MIDSHIP SECTION

S.S. N^o 151 156-157

Builders 410' x 52' x 30' 6" mld. Lloyds 408' 0" x 51' 6" x 31' 54"

Lloyd's Register
Foundation
W619-0049

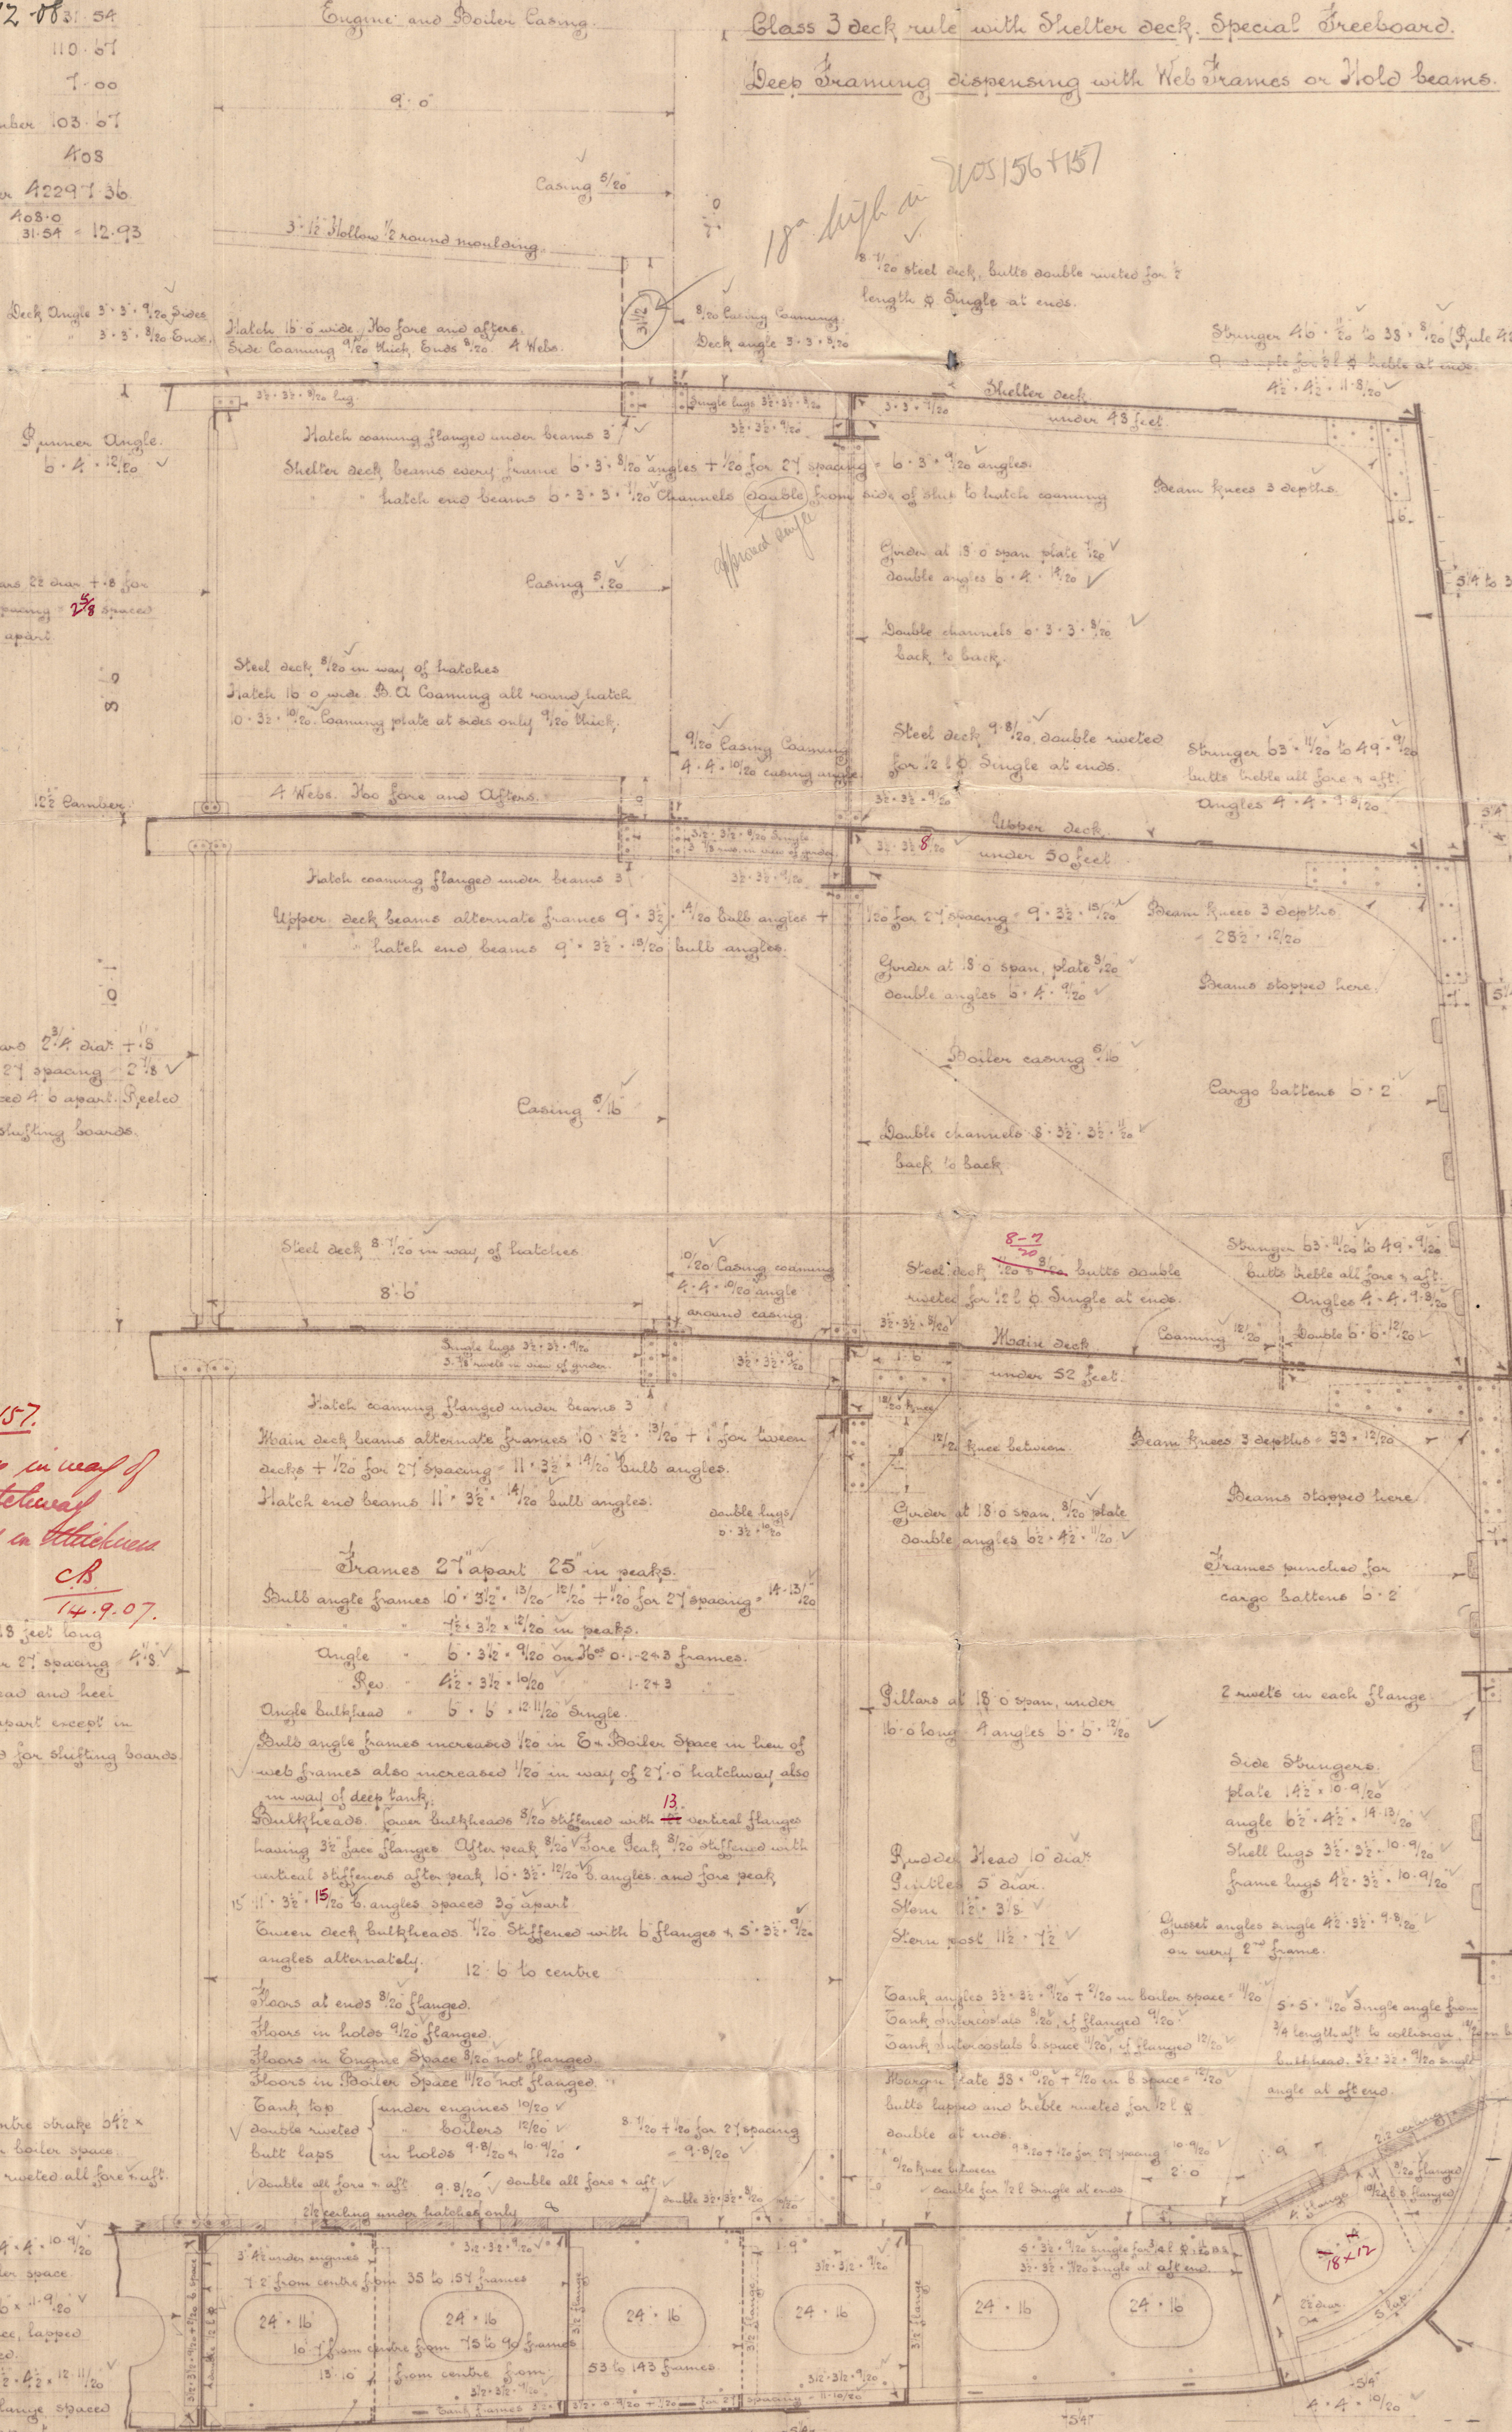
P.S. 1567 15.4.15.7.
The S.A. frame in way of
the 27th hatchway
not increased in thickness
C.B.
14.9.07.

double bottom before the 5' length forward to be spaced not more than 4' apart.
The rivets in the plating and frames in way of same to be spaced not more than 5' apart.
apart. Elsewhere rivets connecting plating to frames to be spaced 6' diameters apart.
